September 13, 2006

Attention: Proposed Plan Comments
U.S. Department of Energy
Rocky Flats Environmental Technology Site
12101 Airport Way, Unit A. Broomfield, CO 80021-2583

RE: Rocky Flats Environmental Technology Site Proposed Plan, dated July 2006

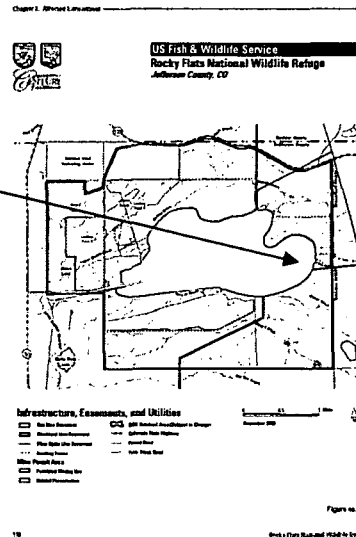
- 3.3.2 We would also be concerned if grazing were allowed in the Americium Area. Erosion would increase in this area and there would be a potential to impact Woman Creek. The runoff in this area would not be captured in C-2 and could potentially leave the site without being monitored. Clarify the basis for figure 3 in the Proposed Plan

(Attachment 1) versus the proposed boundary in the Comprehensive Conservation Plan as identified below.

Area that was removed from new map.
